Supplementary Environmental Impact Statement

Western Desert Resources Limited
Roper Bar Iron Ore Project

Document Reference Number: EZ12022-C0301-EIA-R-0001 D000023784 D

Figure 5-1: Environmental Monitoring Bore

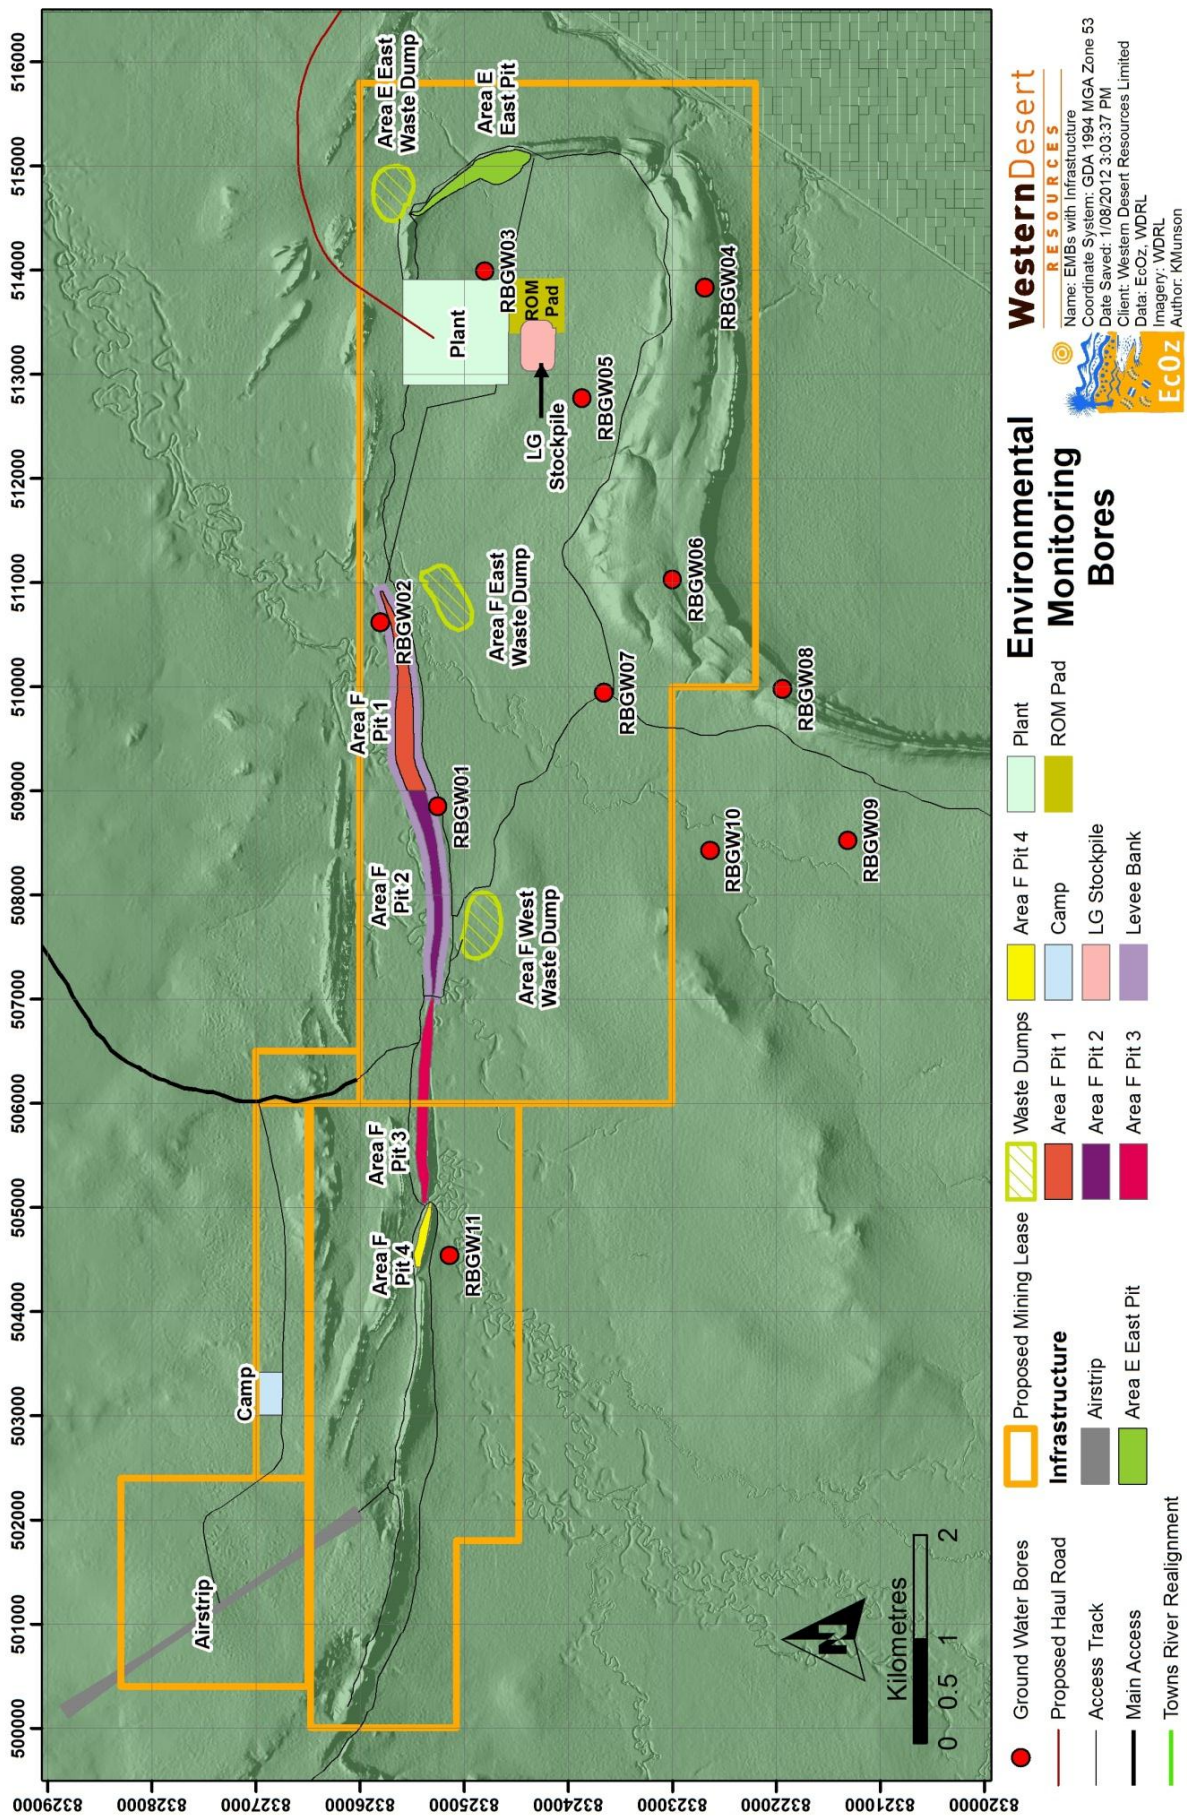
FIGURE 1.3 More information on the disturbance footprint for each of the infrastructure shown on the map is required. Clearing within the mining tenements will total approximately 450 hectares - A breakdown of this disturbance size is required.

Although the airstrip area identified as outside of the WDRL Mineral Lease (ML) is not, and will not be used for any purposes other than a required clear zone as per Legislative Requirements, WDRL plan to submit an application for a new (simple infrastructure) ML for this purpose in the near future.

The following table outlines the disturbance footprint for each of the infrastructure shown in the map (Figure 5-1) below.

Figure 5-5. Provisional WRD Detailed Design – Area F East 2

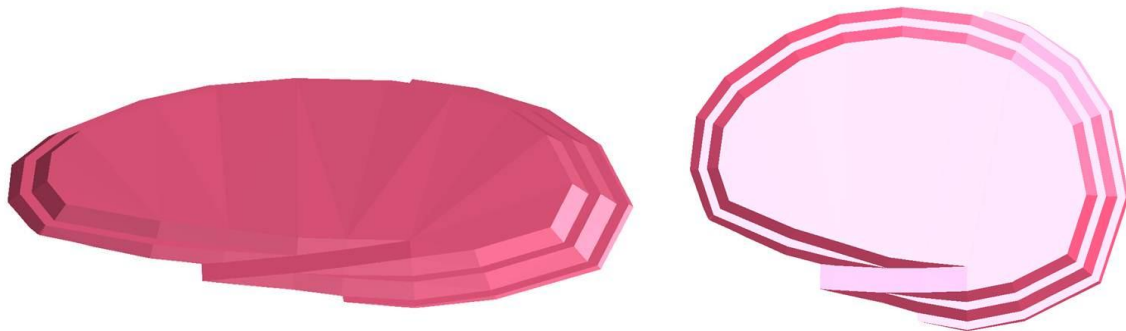
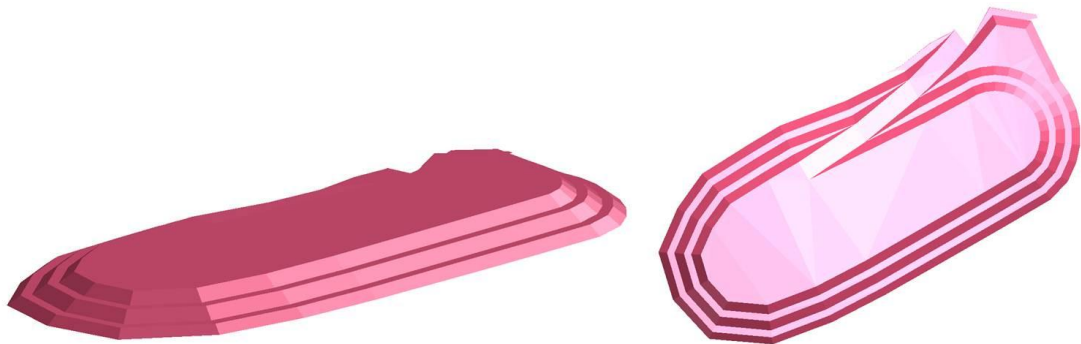
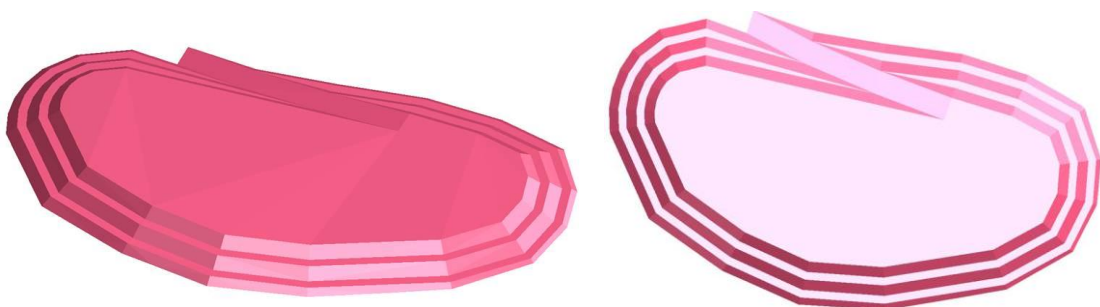
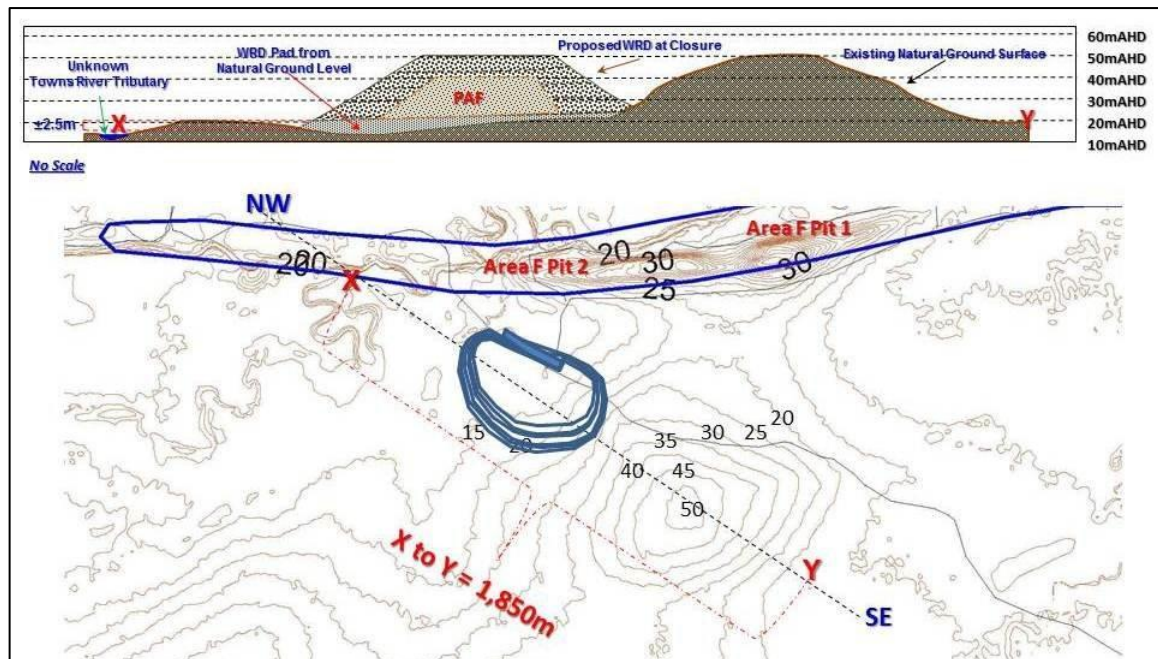
It is stated that the Area E stage 1 pit and Area F pit 4 are planned for use as potential water storages during the early stages of the project. At Table 2-4 summary statistics of the pit dimensions are provided for Area F and Area E and Figure 2-1 provides a general plan view of the proposed pits. Clarification is required on whether pits 1 and 2 of Area F are proposed as separate pits, or are contiguous. The Supplement should also clarify whether the Area E, East pit is to be mined in stages as implied or is to be mined at 10 metres per month uniformly as stated. Dimensions and ore/waste data for each pit (as per pit 4 dimensions at Table 2-17 page 2-68) and waste rock dump should be presented individually given that three waste rock dumps are proposed (Figure 2-1).

Provisional dimensions and area of Waste Rock Dumps is provided below. It should be noted that full comprehensive designs will be established for the MMP, a provisional design is provided at Figure 5-5.

Figure 5-6. Filtration System

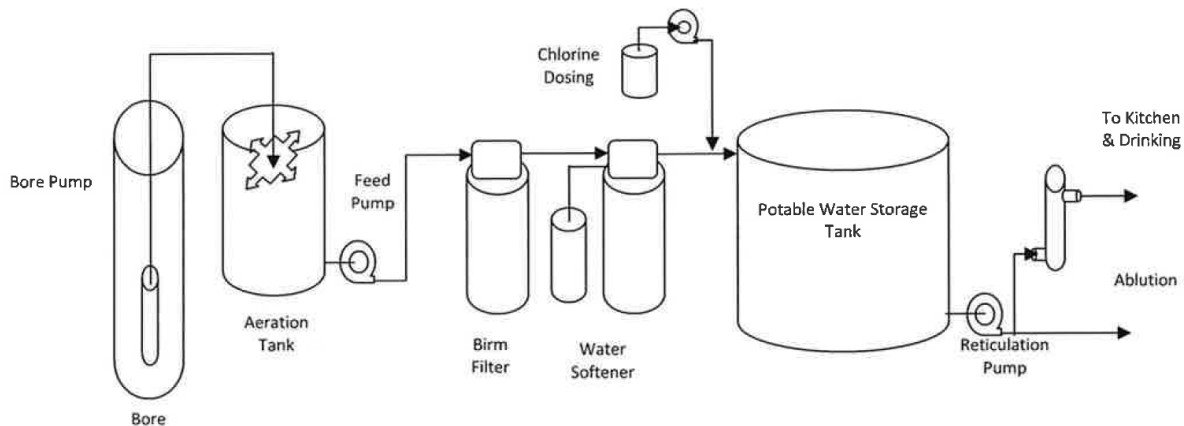
Softening filters remove 'hardness' (Ca & Mg ions), not carbonates. These systems require regular recharging with a consequent backwash of brackish water discuss how this waste stream will be compatible with the proposed waste water treatment system.

Other than the schematic at Figure 2-23, there is no indication of where the raw water dam (RWD) is positioned on site nor how water will be transferred from the pit water store (PWS -pit 4) nor how sediment basin waters will be transferred to supplement the site water requirements. Taking into account the above, provide further information with respect to the availability and management of water resources to sustain the mining operation for the duration of the mine life.

Below outlines how the system operates (see Figure 5-6):

- Bore water is pumped into an aeration tank to oxygenate the water;
- Oxygenated water is pumped into the Birm filter to filter out ferric oxide;
- Filtrate is softened with a water softener using cation exchange;
- Chlorine is dosed as water flows into a storage tank;

- Softened and chlorinated water is stored in the potable water storage tank;
- On demand, water is reticulated to the camp site for ablution and kitchen for cooking and drinking; and
- A UV steriliser will be installed on the Kitchen and drinking water supply feed.

Figure 5-9: Bing Bong Environmental Monitoring Bores (proposed)

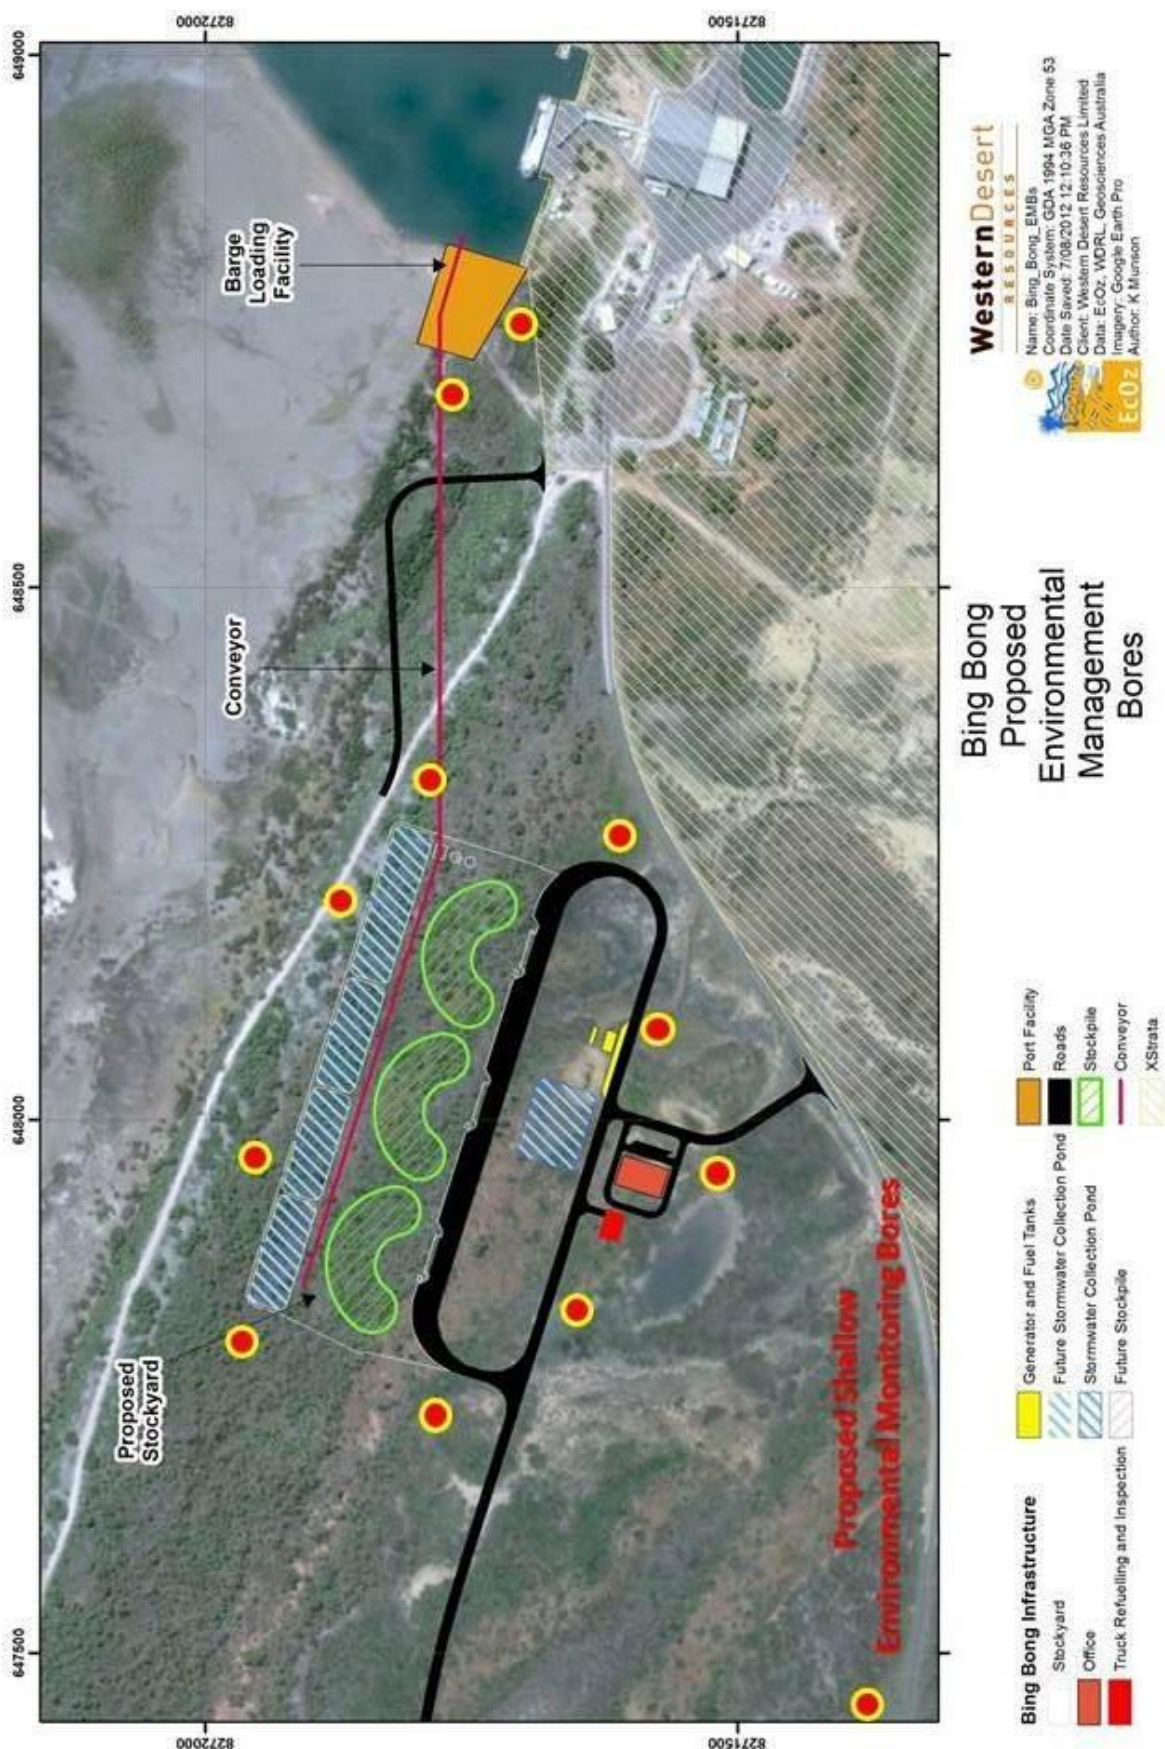
Groundwater bores should be installed around the Bing Bong facility to establish any impacts from seepage of sediment ponds.

Noted. Please see map below for additional bores as requested.

Figure 5-10: Haul Road Catchment Plan (No2)

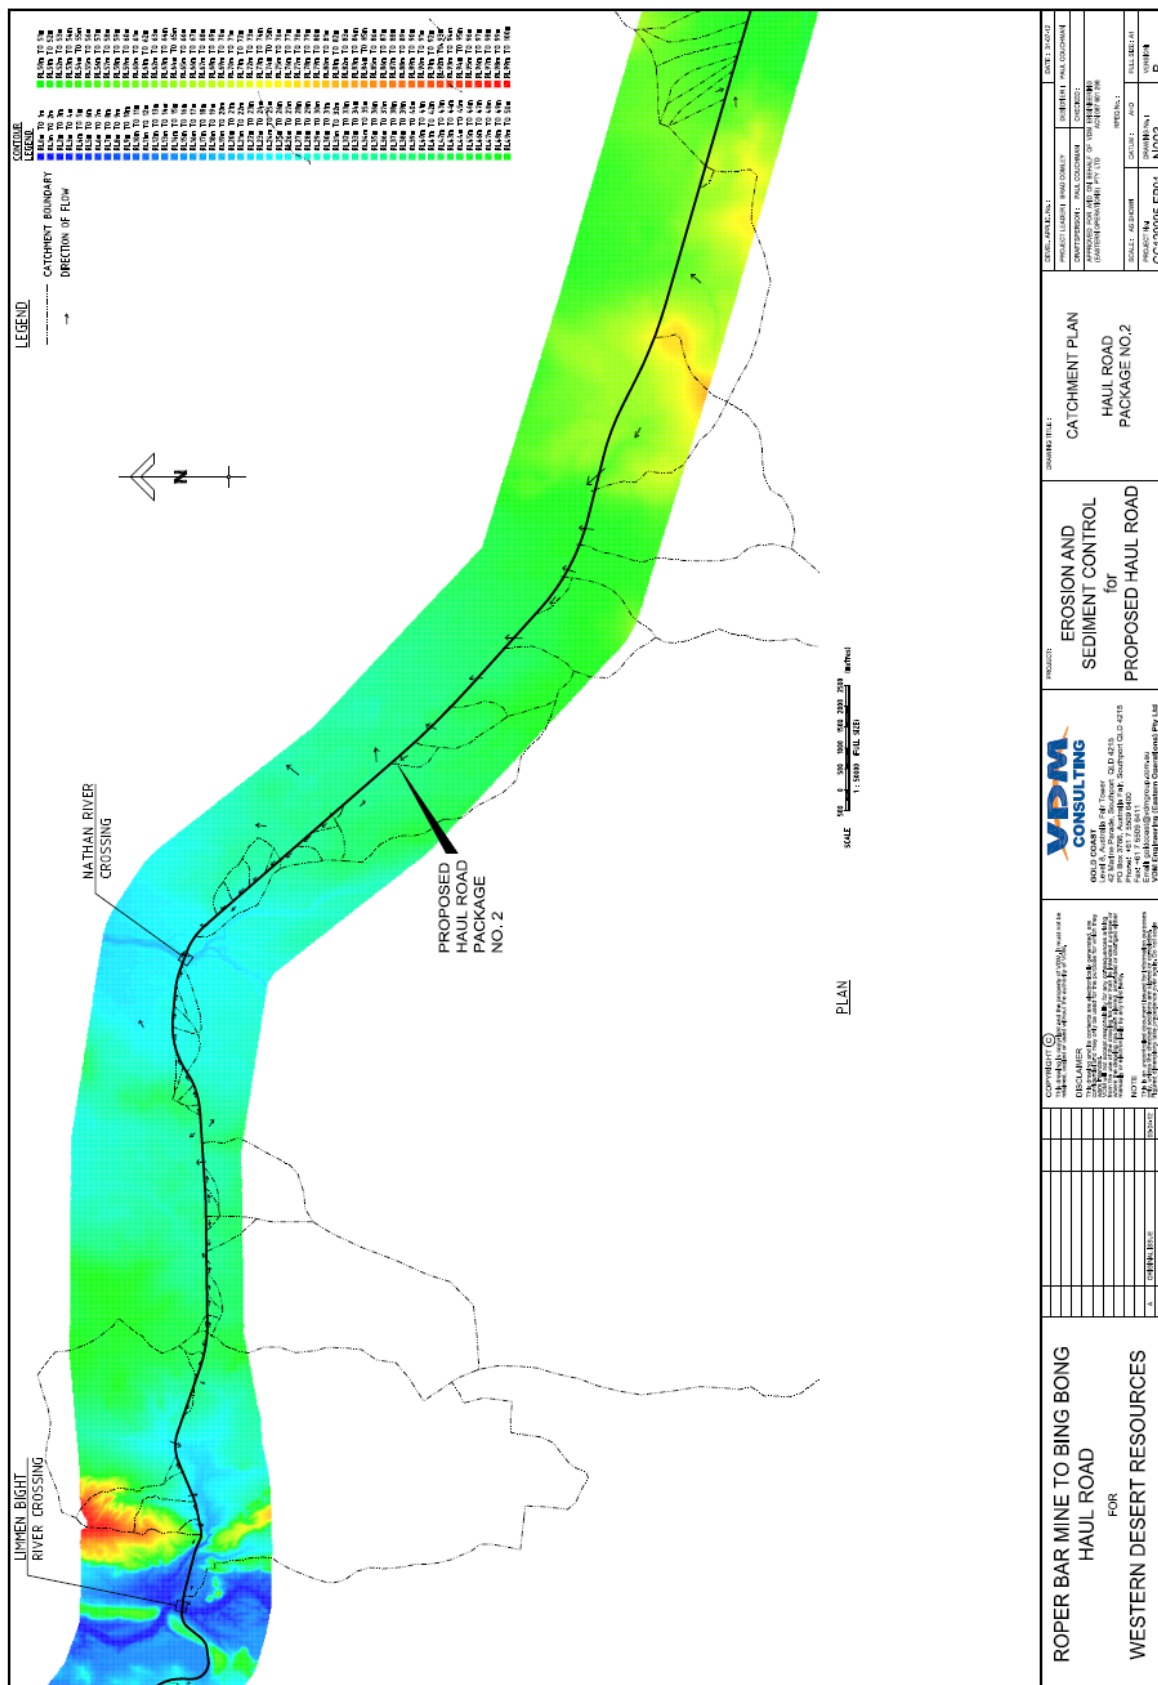
The Catchment Plan for Haul Road Package N0 2 (Drawing N003) should include the road and sub-catchment boundaries.

See image below.
